E8363BH85-07**S E R V I C E N O T E**Supersedes:
NONE**E8363BH85 PNA Series RF Network Analyzers****Serial Numbers: MY00000000 - MY47030103****Add-on mechanical components to enhance instrument reliability****To Be Performed By: Agilent-Qualified Personnel or Customer with specific product repair knowledge – requires instrument disassembly and component replacement.****Parts Required:**

Rev. 14

McMaster Carr item 6959A18 (T-10 torx size L-key)

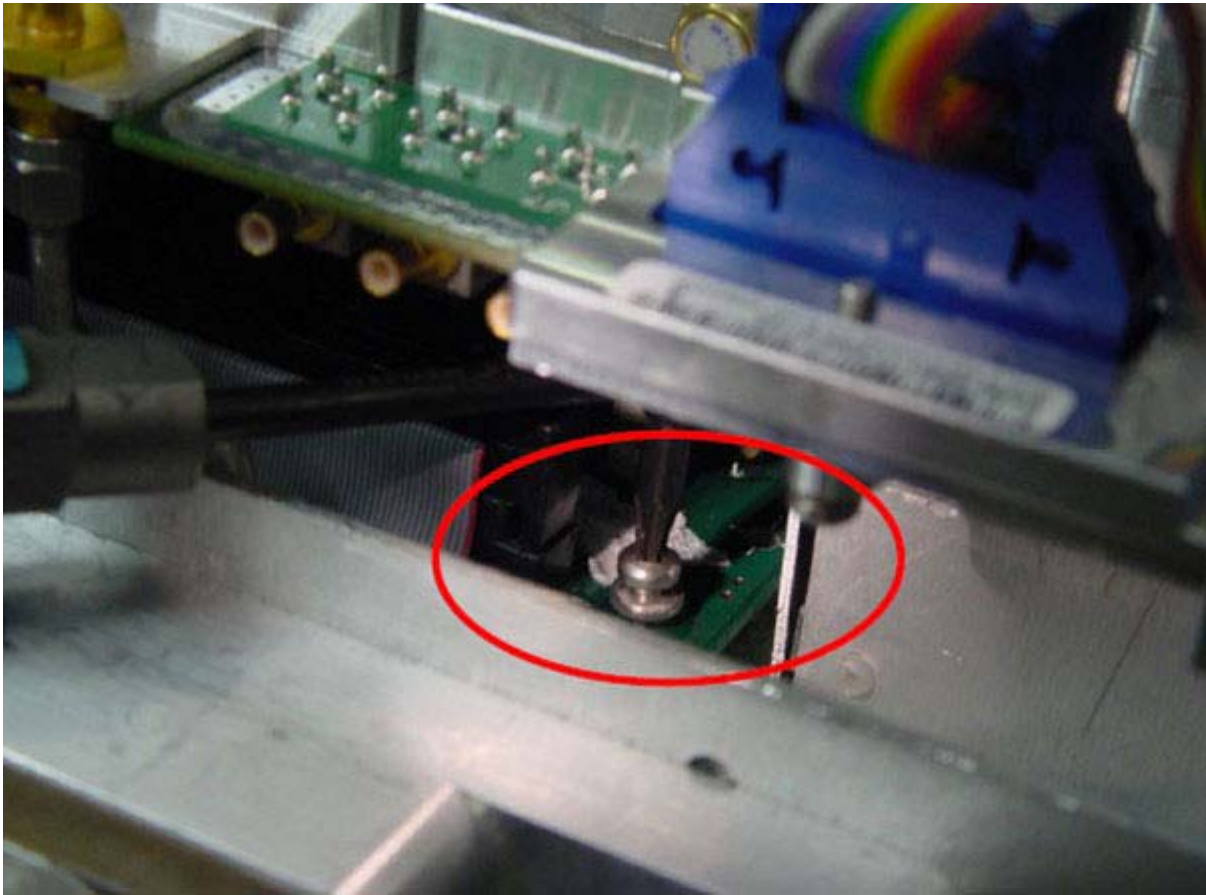
- b. Remove the open end head by loosening set screw. It will be replaced with L-Key shown below.

- c. Secure and orient the L-Key to the breakaway handle

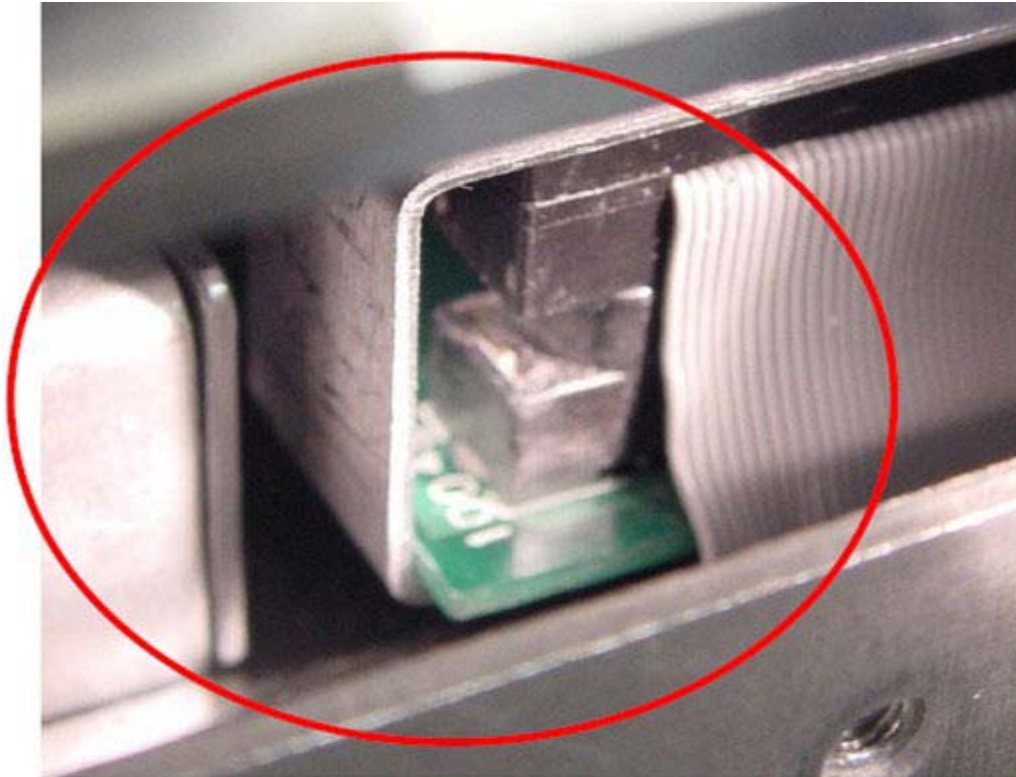
- a. Remove and discard existing screw near ribbon cable connector on System Motherboard. See below.

- b. Insert Ribbon Cable Clamp under Source Assembly as shown.

- c. Position the clamp over the Ribbon Connector. Use needle nose pliers if necessary to slide the clamp into place. Ensure that the edge of the clamp is parallel to the connector and not skewed.

NOTE: Ensure that the Clamp Lip is secured BELOW the edge of the System Motherboard

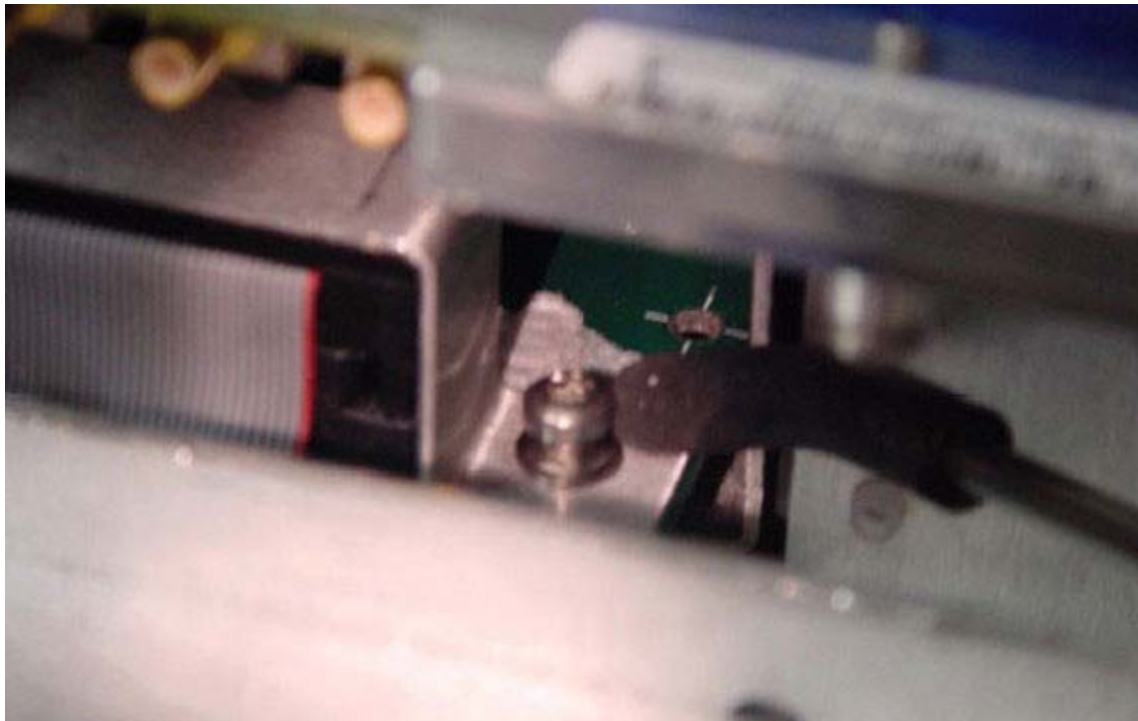
- d. Using tweezers, install a new 0515-0374 screw through the hole in the bracket.

- e. Use a nut runner tool (T-316130) or alternatively a clean erasure end of a pencil to help run the screw.

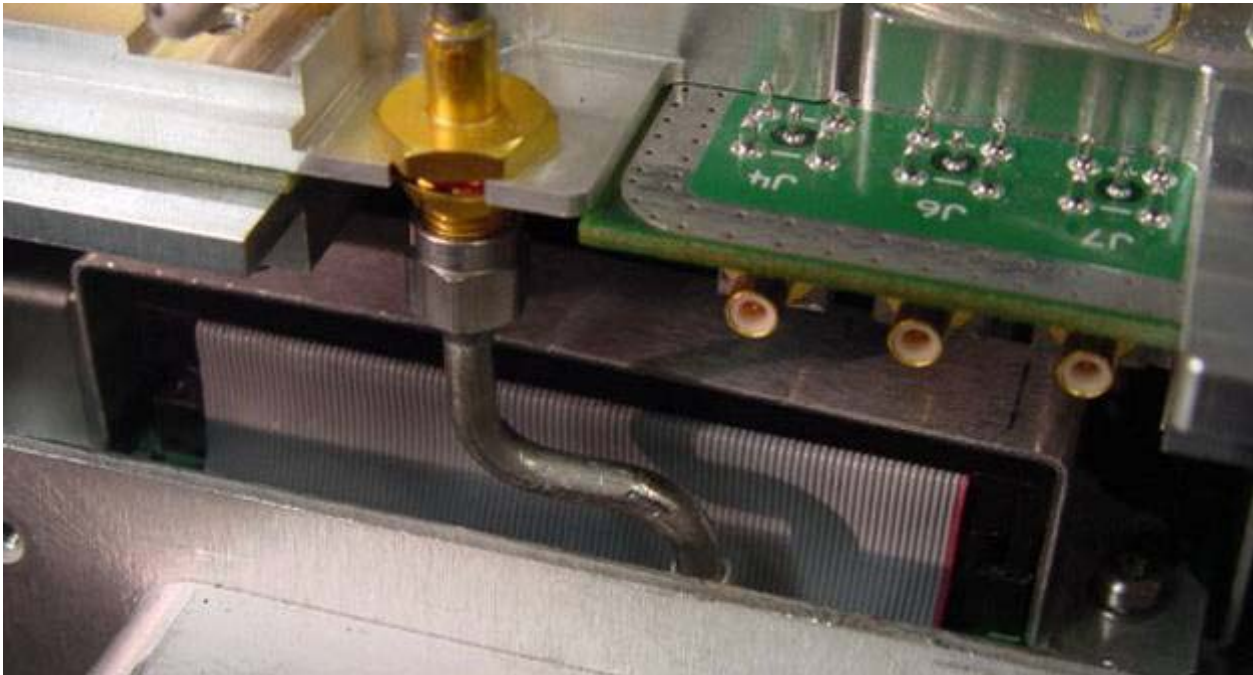
- f. Secure screw using the modified 10 lb-in breakaway wrench.

- g. This image shows the final position of the secured clamp.

Figure 2a

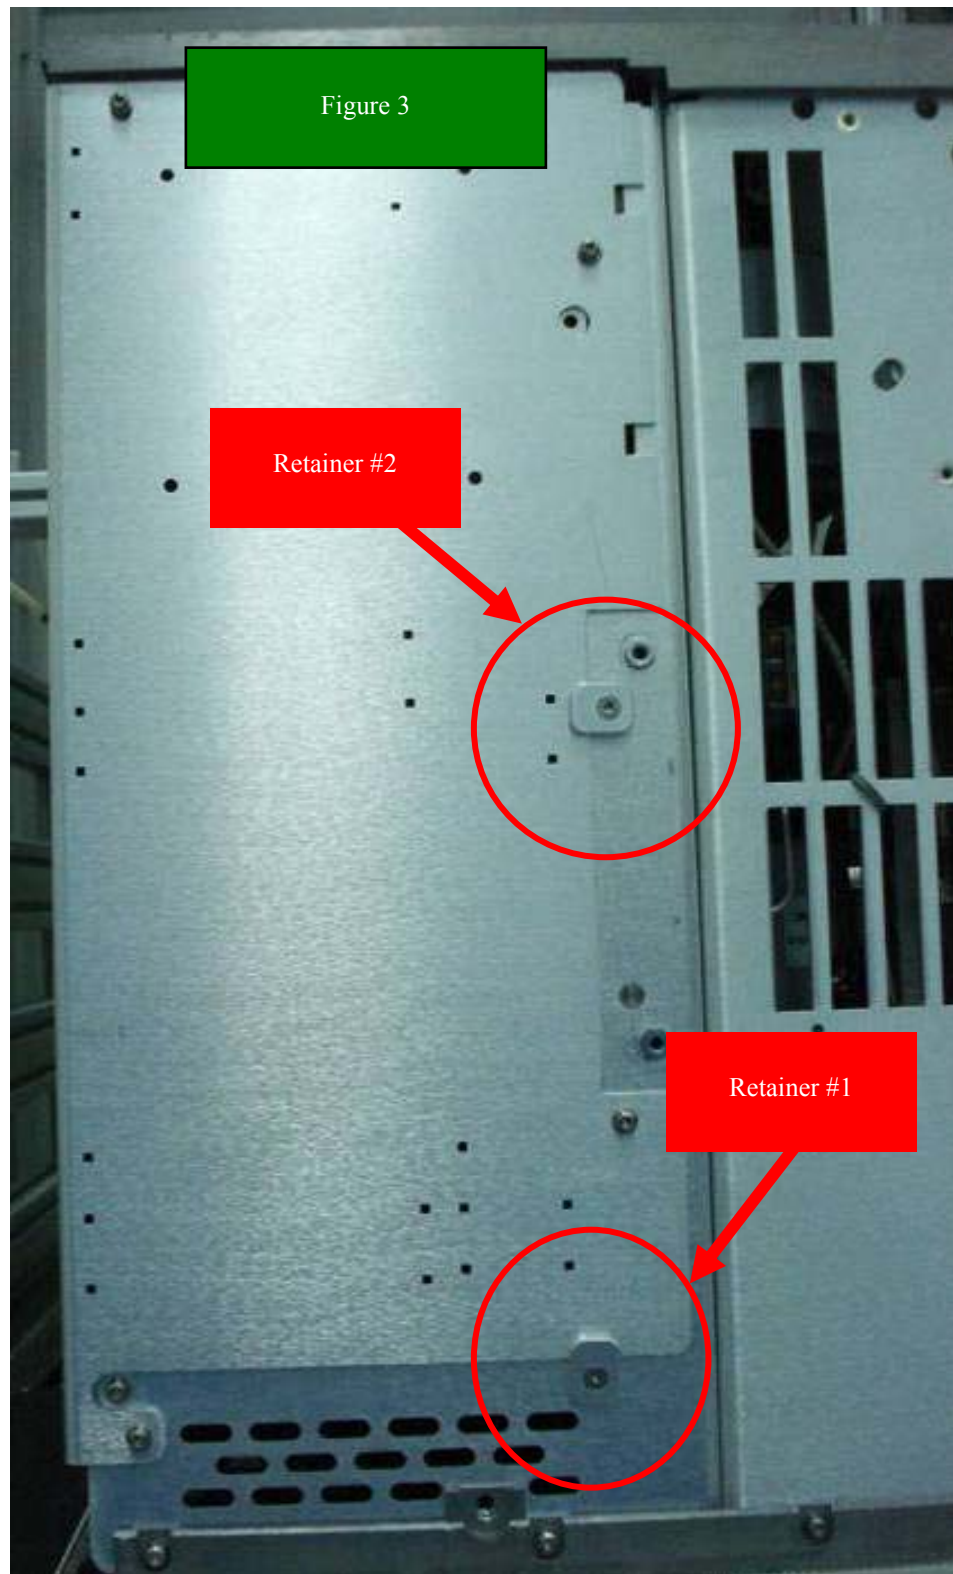
The Clip Retainer (E8361-20067) to be secured with Flat Head screw (0515-1644) in 2 places at 9 lb-in. This Retainer Clip may naturally rotate a bit when being secured, which is acceptable. Note that the existing screw needs to be removed and discarded prior installing Retainer Clip #1 (shown below in Figure 2a, 2b, and 3).

Figure 1:
Patch-Lock Screw (0515-2799)
And
Flat Washer (3050-0891)

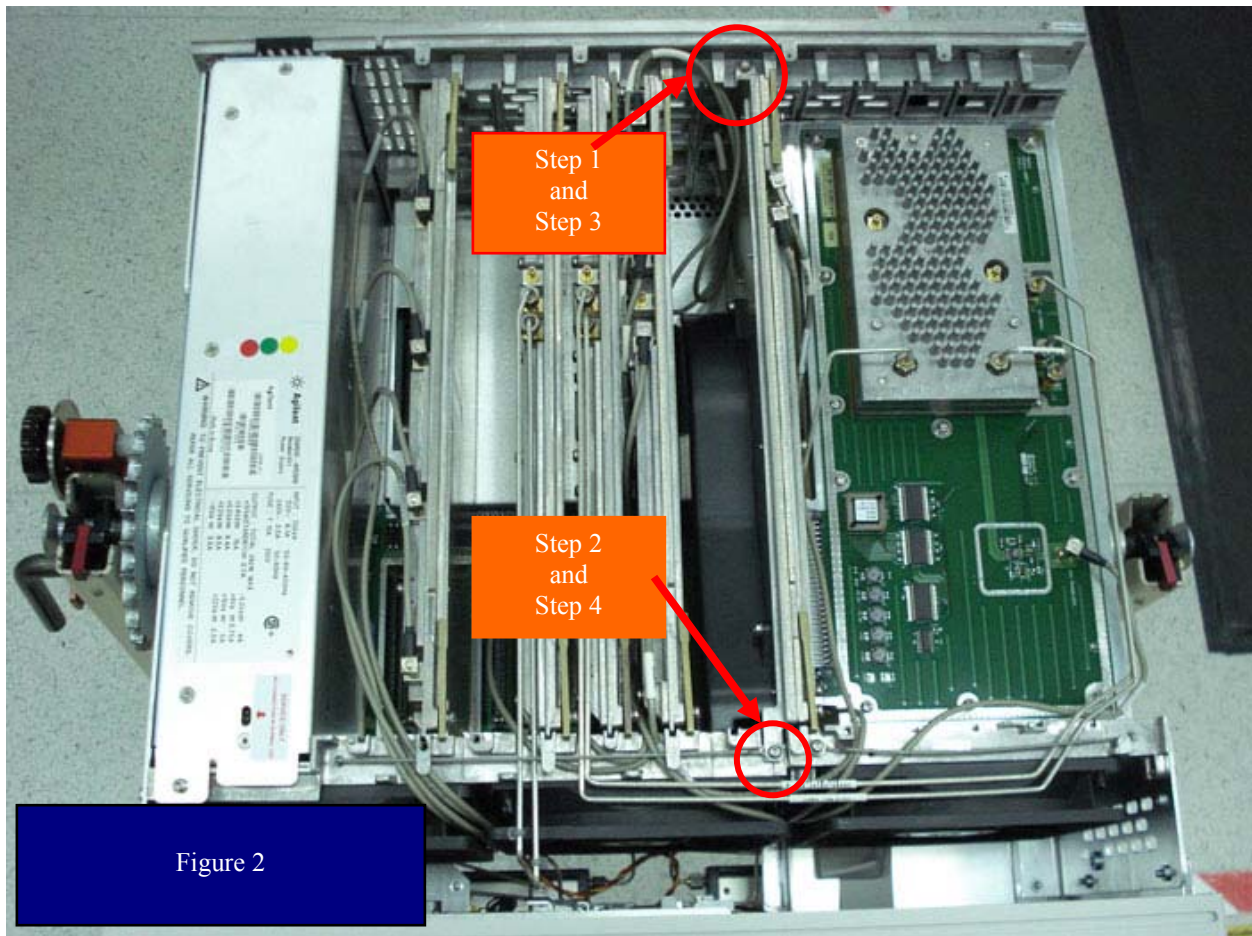
The Patch-Lock Screw (0515-2799) and Flat Washer (3050-0891) to be used in 2 places and secured at 9 lb-in. These parts will replace existing screw (0515-0374) used in Step 3 and Step 4 (as shown in Figure 2) to secure the Phase Lock Board (E8364-60137).
